**Re: Final Revised Proposed Plan for LHAAP-47, Plant 3 Area, Solid  
Rocket Motor Fuel Production Longhorn Army Ammunition Plant,  
Karnack, Texas**

Comments Response Matrix  
Draft Report: Revised Proposed Plan for LHAAP-47, Building 46A Plant 3 Area,  
Solid Rocket Motor Fuel Production, Longhorn Army Ammunition Plant, Karnack, Harrison County, Texas  
Submitted: April 20, 2021

***FINAL***  
**REVISED**  
**PROPOSED PLAN**  
**FOR LHAAP-47**  
**PLANT 3 AREA, SOLID ROCKET MOTOR**  
**FUEL PRODUCTION**  
**LONGHORN ARMY AMMUNITION PLANT,**  
**KARNACK, TEXAS**  
**ISSUED BY: U.S. ARMY**

**Figure 1. CERCLA Remedial Response Process for Site Cleanup**

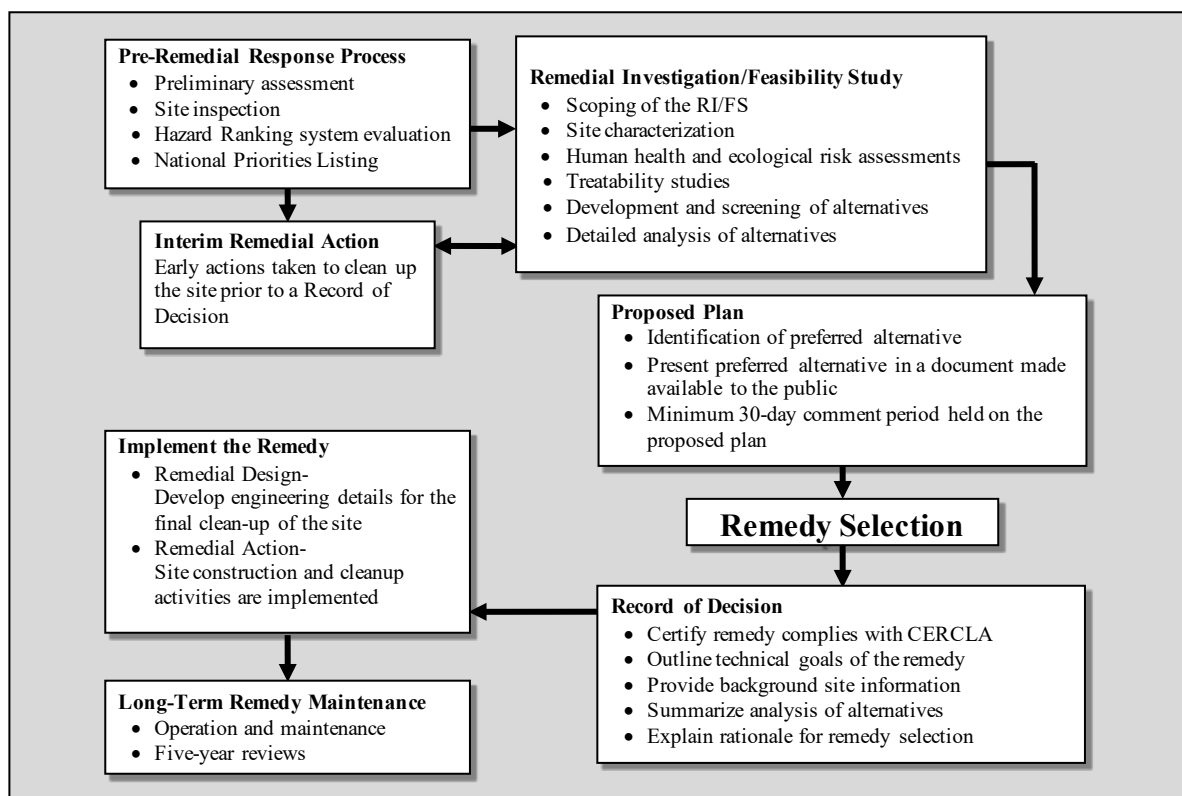
Number	Section/ Page	Paragraph /Line	Comment	C,D	Response	A,D	Draft Final Comment	C,D	Draft Final Response
3.	Intro, pg. 3		2 <sup>nd</sup> complete paragraph: a) Can you put Figure 1 before this paragraph? It is referenced in 1 <sup>st</sup> full paragraph on page. b) RI Report needs a date. c) Revise to Marshall Public Library (remove “, Texas”) d) Fix break after word “Environmental”	E C C C	a) The figure follows at the top of the next page because there isn’t sufficient space to retain the same figure size after changing the two column formatting in the middle of the page. b) The RI report reference for Jacobs, 2002 has been added. c) The text has been revised as requested d) The formatting has been corrected.	A/D	Please remove the comma in “Marshall Public Library”	C	The comma has been removed.

FIGURE 2

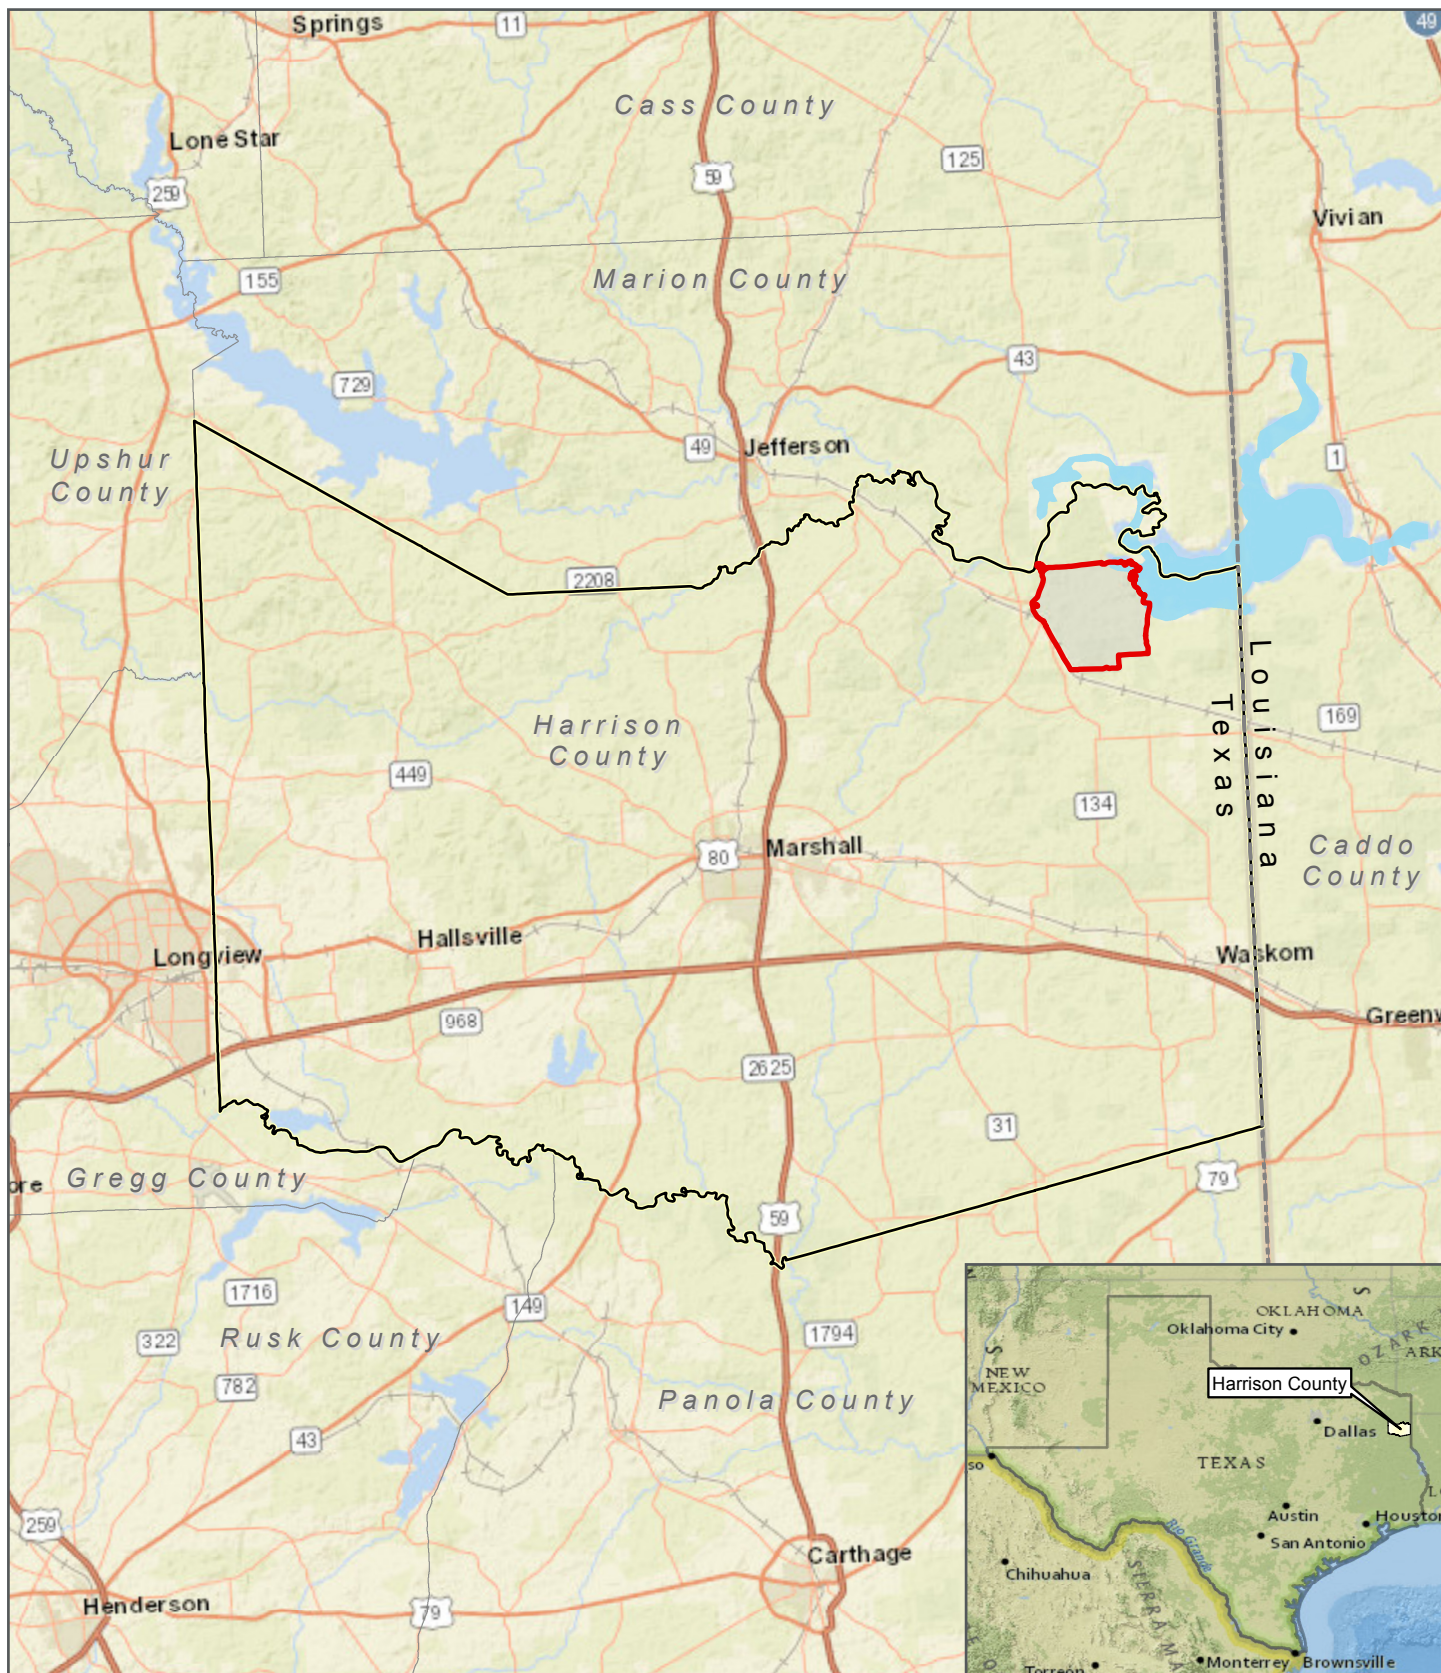
4.	Pg. 5		Figure 2 is not very clear. Please insert a higher resolution image.	C	The figure has been replaced with a higher resolution site location figure.	A

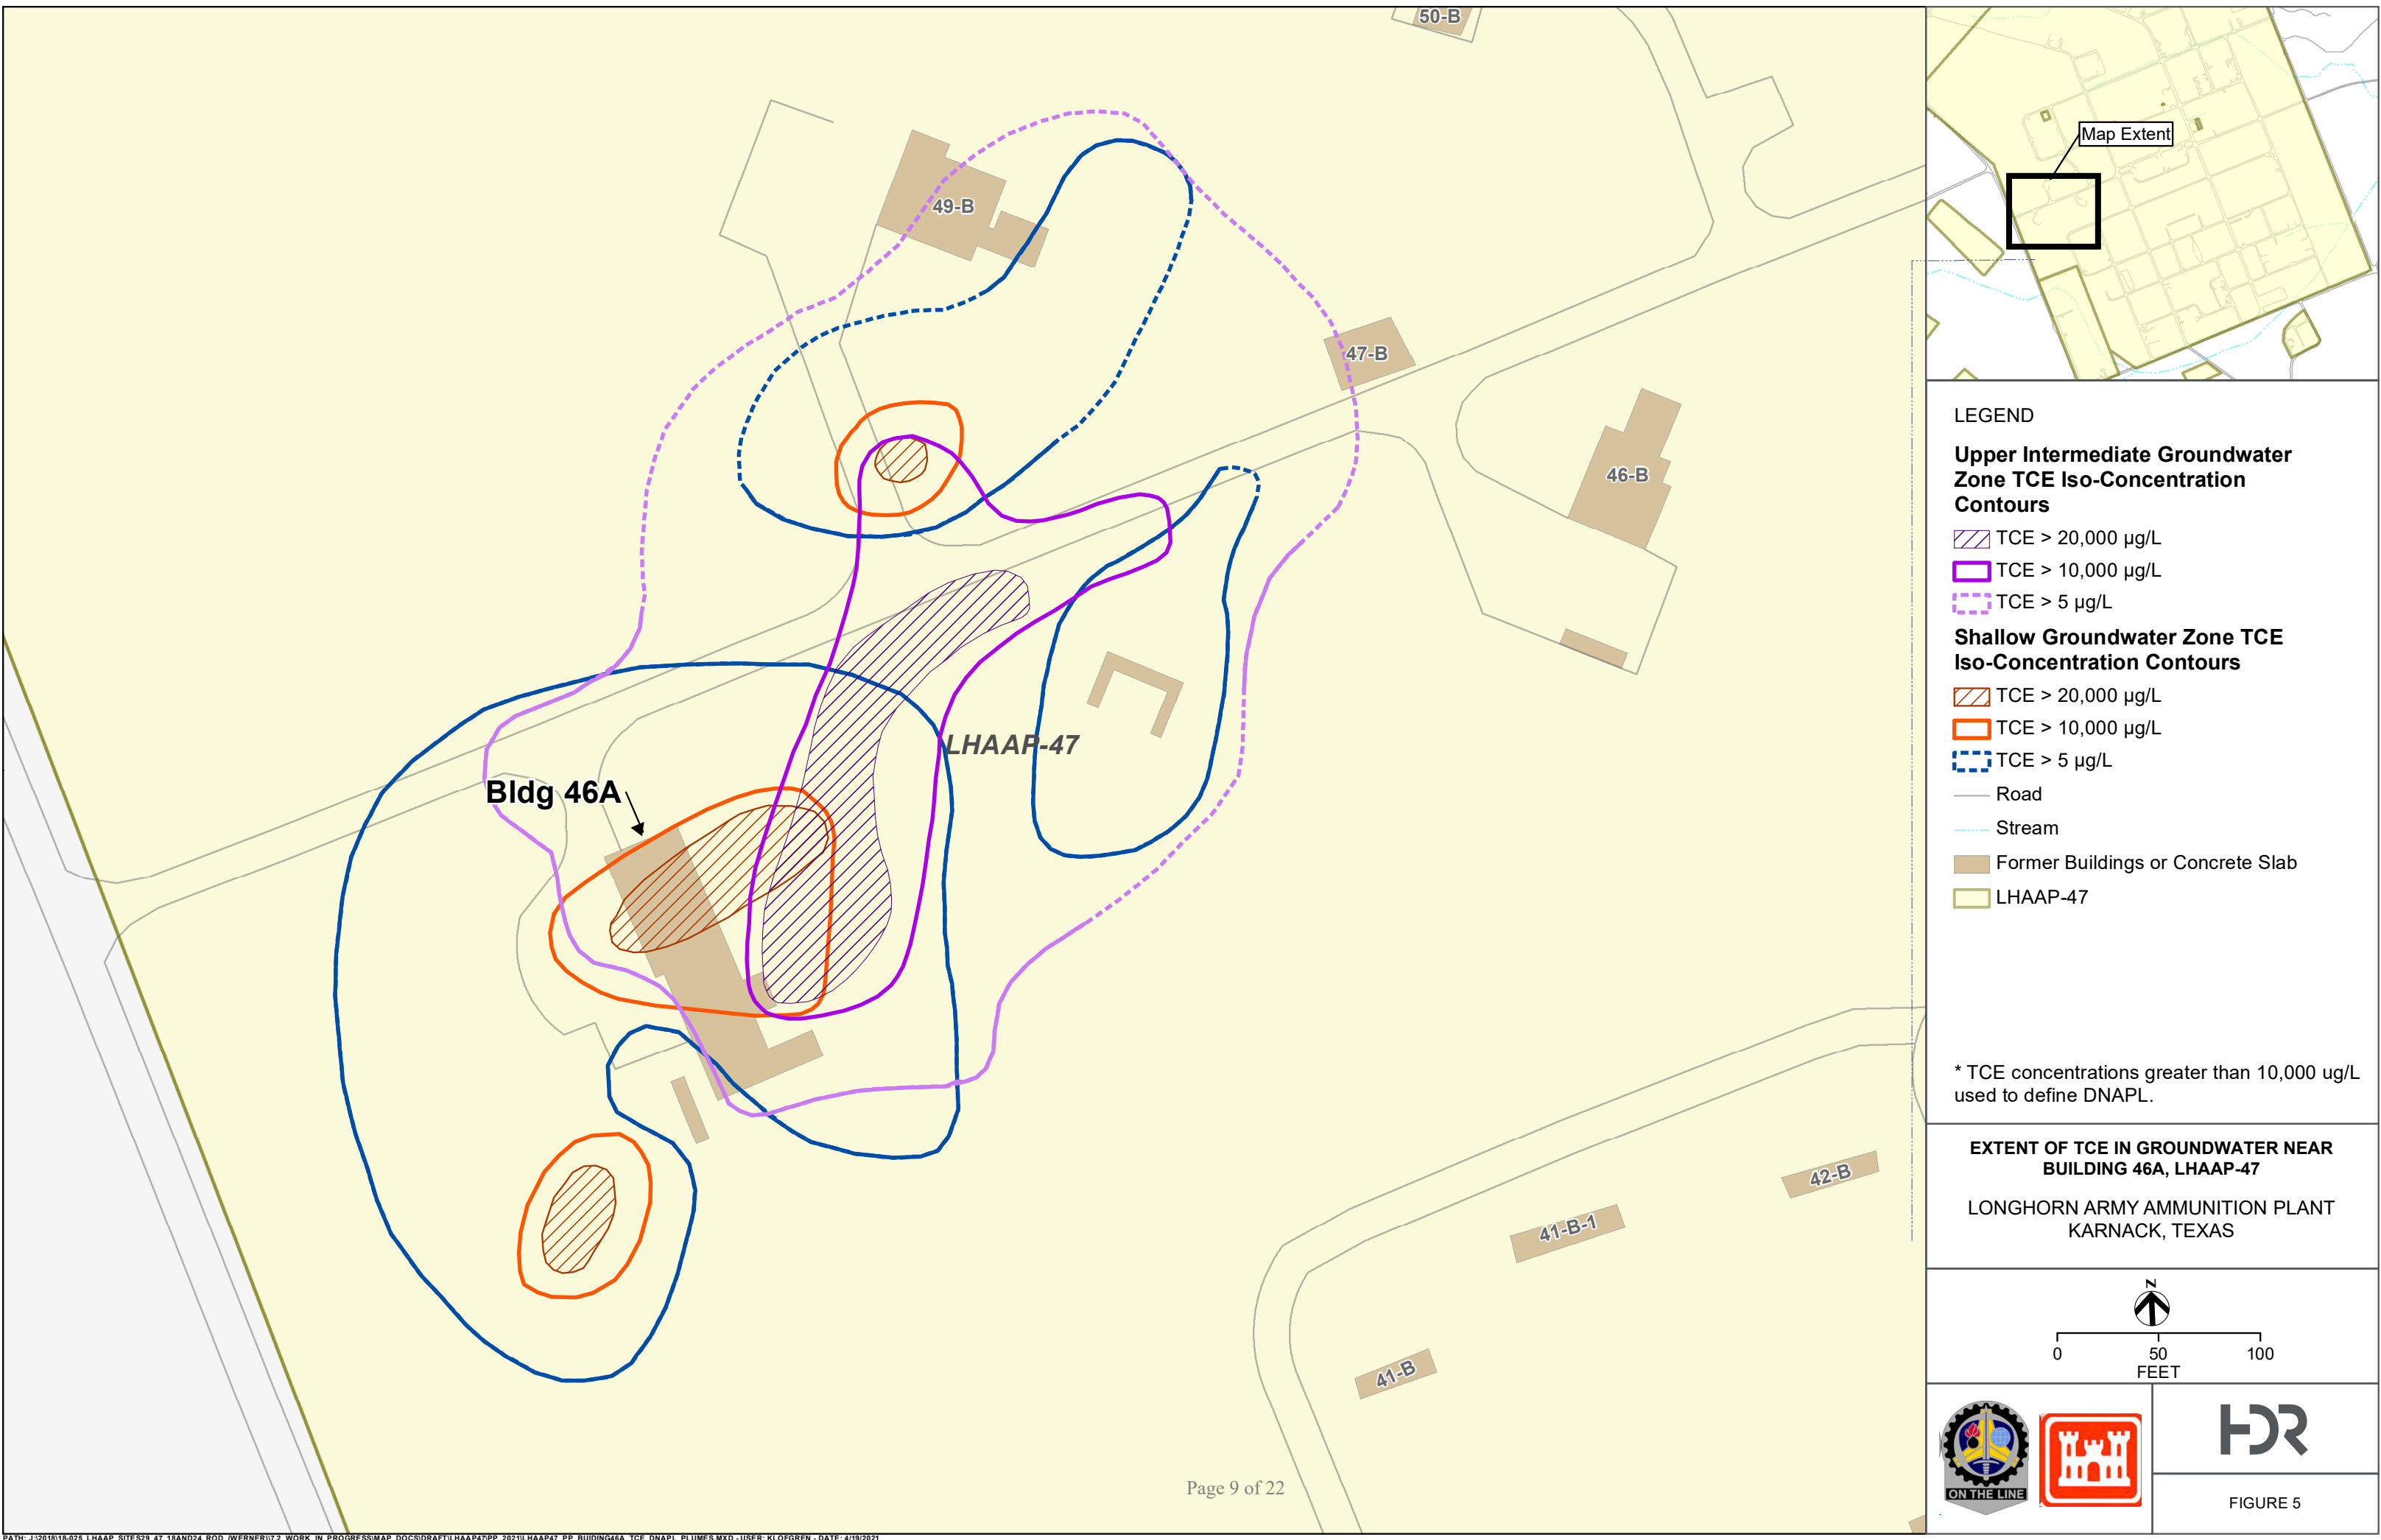
15.	Page 6	Last paragraph, second column	Figure 5 shows shallow and upper immediate contamination, but previously, intermediate contamination is mentioned. The site characterization section the text discusses four zones, one with an additional second name (i.e., upper intermediate). For clarity for the public, consider adding some text here explaining contamination in each zone.	C	The 3 <sup>rd</sup> paragraph of the Site Characteristics section has been revised to include a description of the groundwater zones as defined in the RI and modified based on PSI results.	A
